**Subject: Remedial Action Work Plan Addendum #2  
77<sup>th</sup> Street Parking Lot Site  
Jackson Heights, Queens, New York  
VCP Site #V00182  
VCA No.: W2-0854-9906**

Louis Berger & Associates, P.C. (Louis Berger) hereby submits this Addendum #2 to the New York State Department of Environmental Conservation (NYSDEC)-approved Remedial Action Work Plan (RAWP) dated April 7, 2008. This addendum has been prepared to address semi-volatile organic compound (SVOC) impacts to surficial soils, and it summarizes investigational activities and the planned remedial approach.

Figure 2 – Proposed Excavation Areas

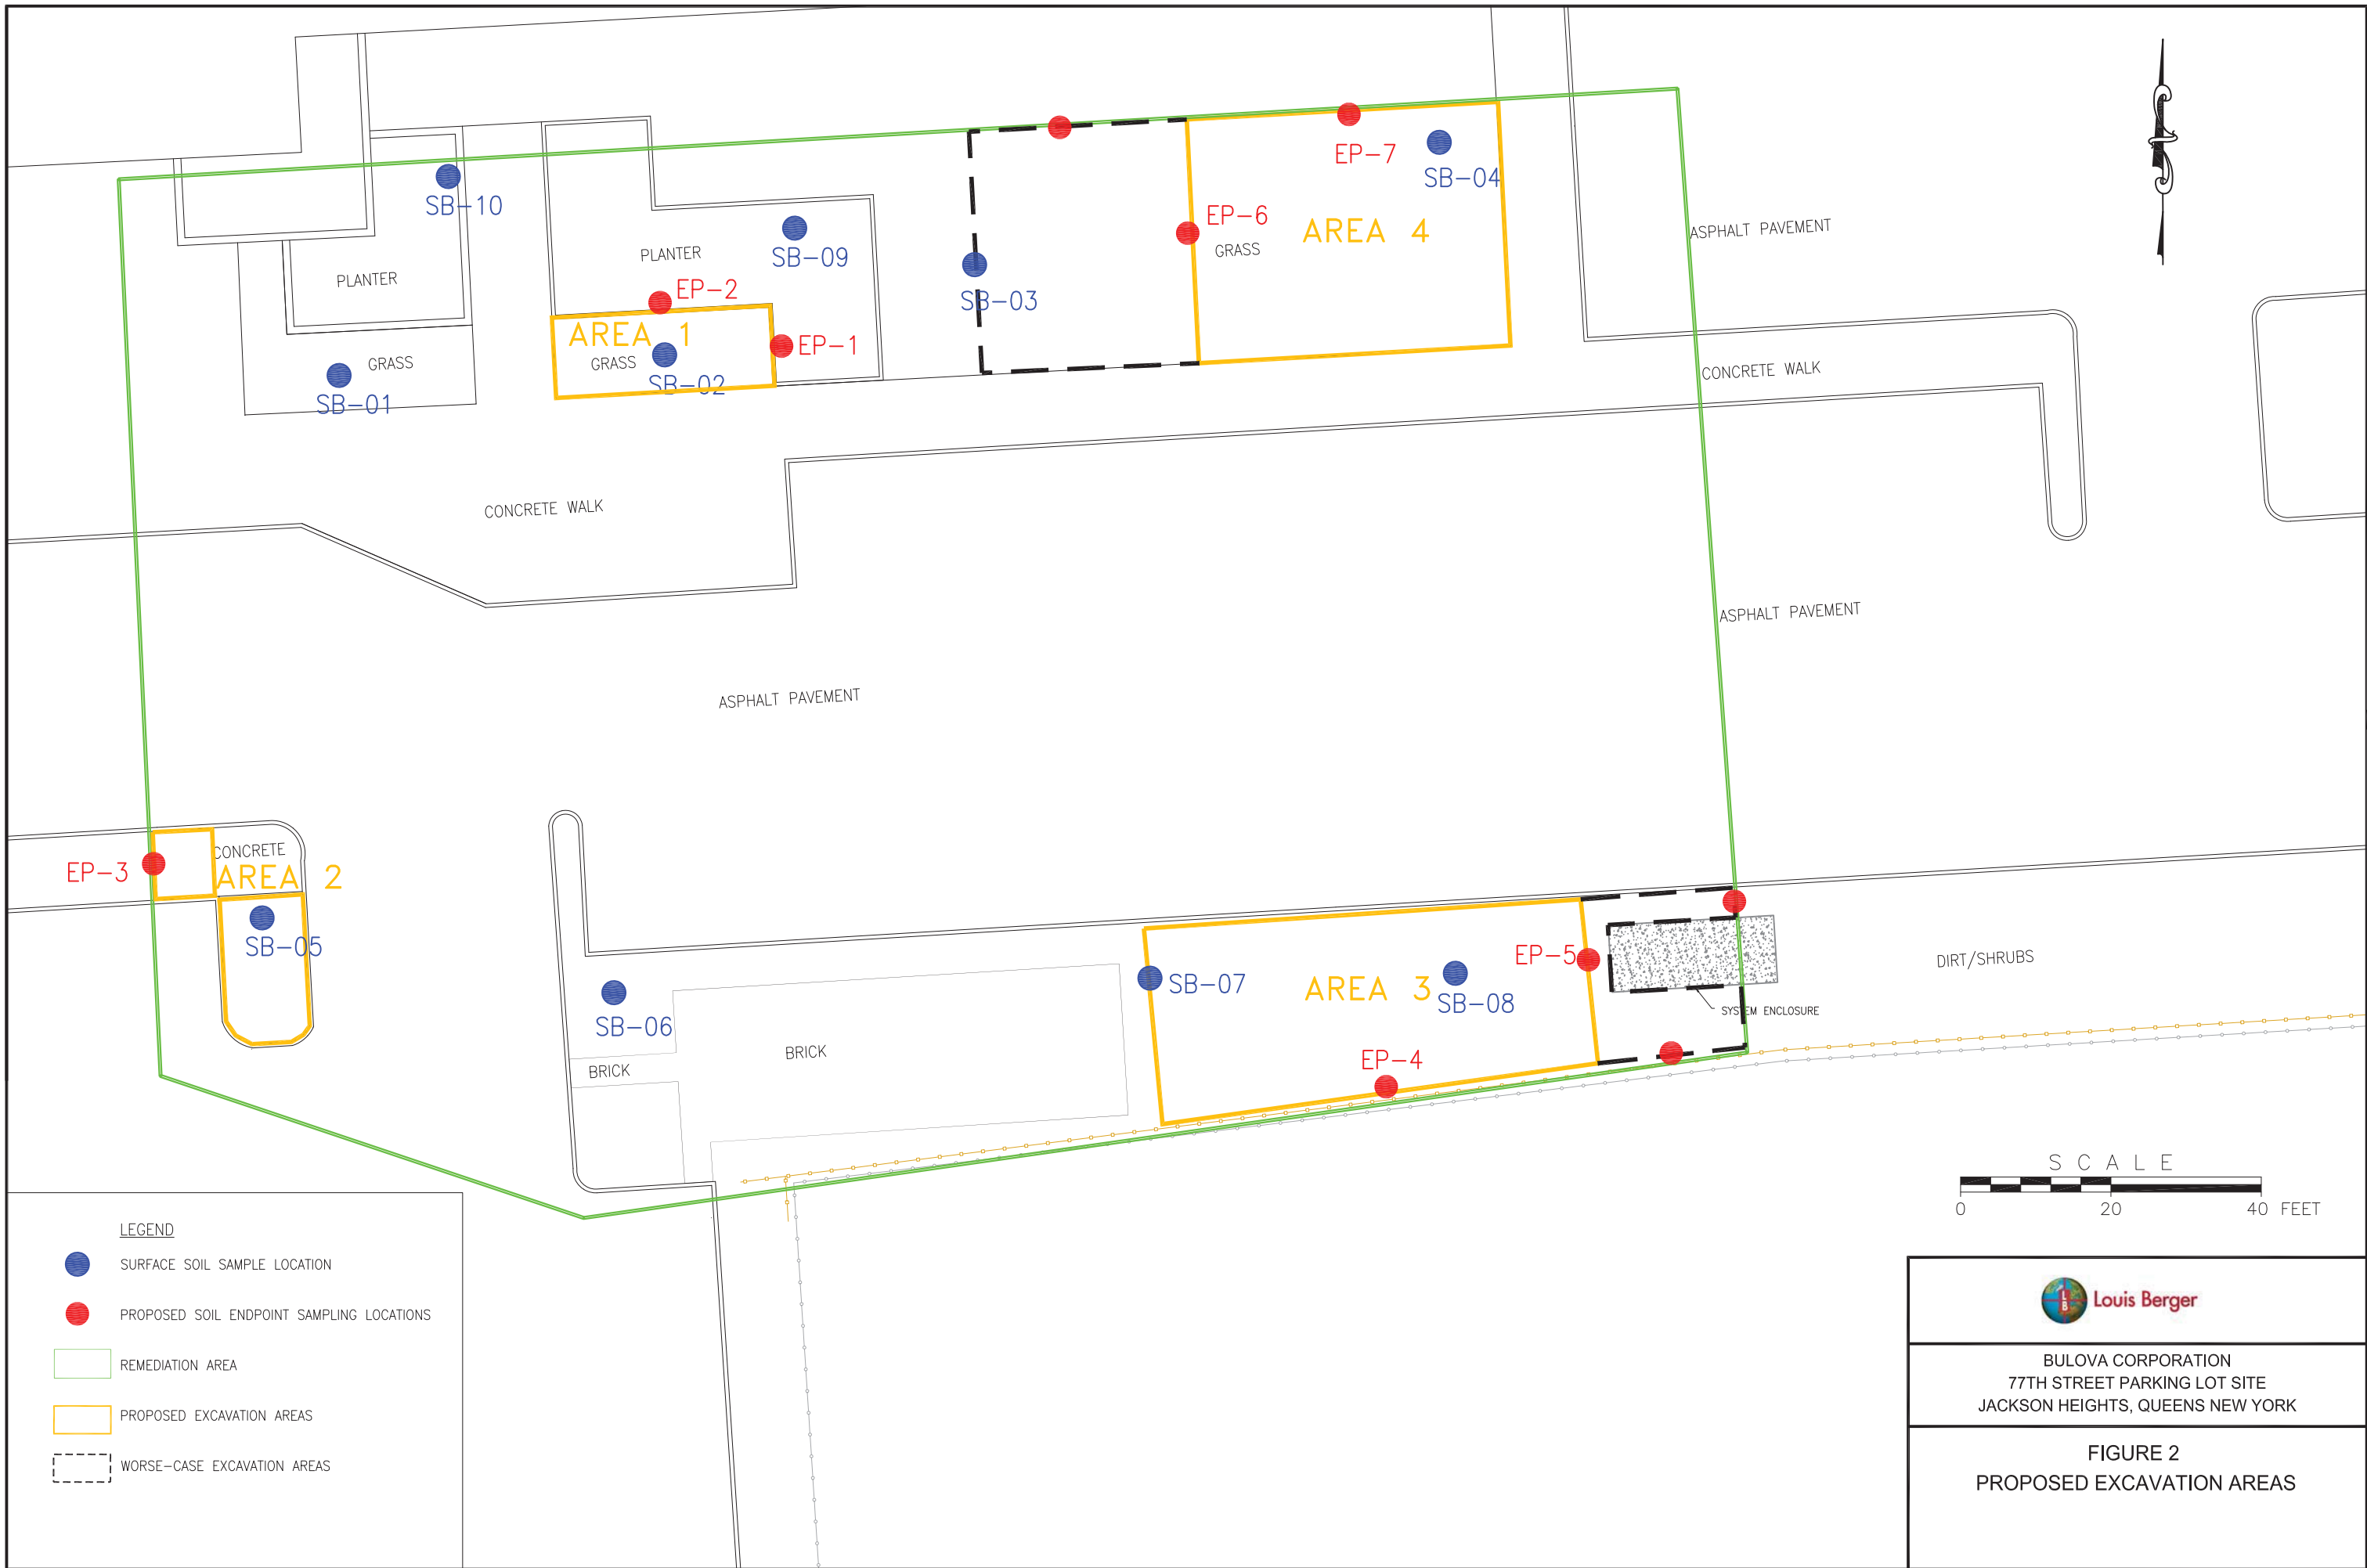
Removal of contaminated surficial soil will occur from four (4) landscaped areas across the Site, designated as Areas 1 through 4. These areas are depicted in Figure 2. The excavation at Area 1 will involve the removal of approximately 18 cubic yards (yd<sup>3</sup>) of soil; at Area 2, approximately 25 yd<sup>3</sup> of soil; at Area 3, approximately 93 yd<sup>3</sup> of soil; and at Area 4, approximately 95 yd<sup>3</sup> of soil.

Following excavation of the soils, soil endpoint samples will be collected from each sidewall that abuts either native material beneath landscaped areas not being excavated, or the Site boundary. Sidewall samples will not be required for sidewalls that abut existing asphalt or concrete caps. In addition, bottom endpoint samples will not be required as these soils will be present beneath the demarcation layer. Endpoint samples will be analyzed for SVOCs and TAL Metals only. Proposed soil endpoint sampling locations are depicted on Figure 2.

For Area 3, if proposed endpoint sample EP-5 contains any SVOC or metal analytes in exceedance of RRSCO, then Area 3’s excavation area will be extended easterly to the Site boundary. For Area 4, if proposed endpoint sample EP-6 contains any SVOC or metal analytes in exceedance of RRSCO, then Area 4’s excavation area will be extended westerly up to soil boring SB-03, a known location that meets all RRSCOs.
